MY2 FINAL MONITORING REPORT Banner Branch Mitigation Project Stokes County Roanoke River Basin CU 03010103

DMS Project # 100080

RE: WLS Responses to NCDEQ DMS Review Comments for Task 8 Submittal, Draft Monitoring Year 2 Report for the Banner Branch Mitigation Project, DMS Full-Delivery Project ID #100080, Contract #s 7610 & 7701, Roanoke River Basin, Cataloging Unit 03010103, Stokes County, NC

1 C

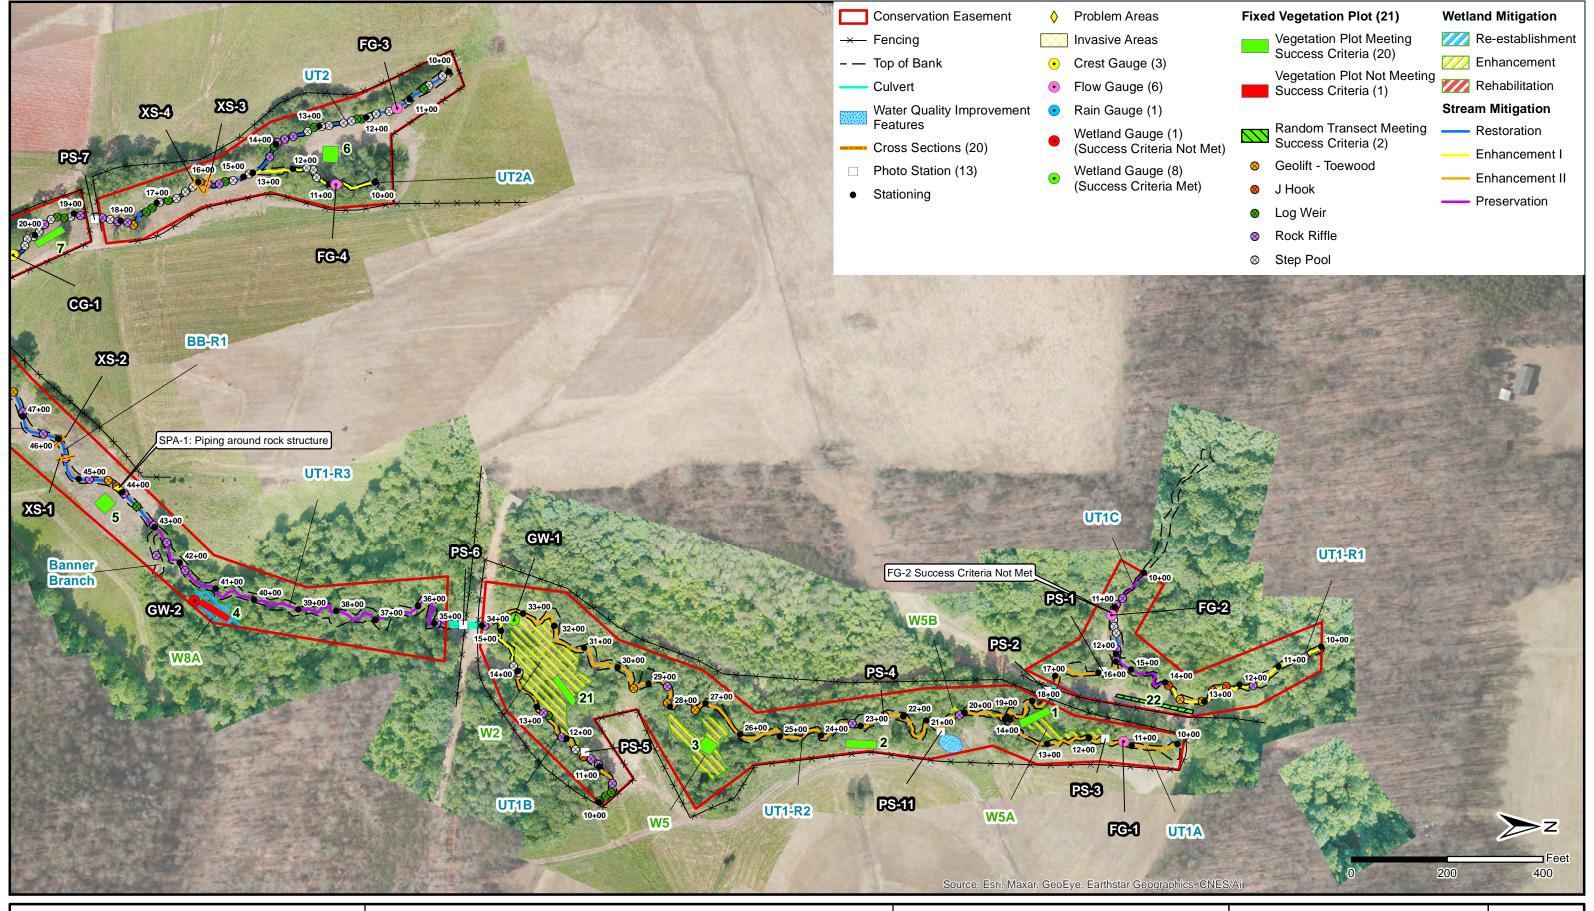
- 3. Flow Gauge 2 should be shown on the CCPV (Figure 1d) as not meeting success criteria. A simple callout with the FG-2 label would suffice or use an alternative color. Response: A callout was added stating FG-2 did not meet success criteria.
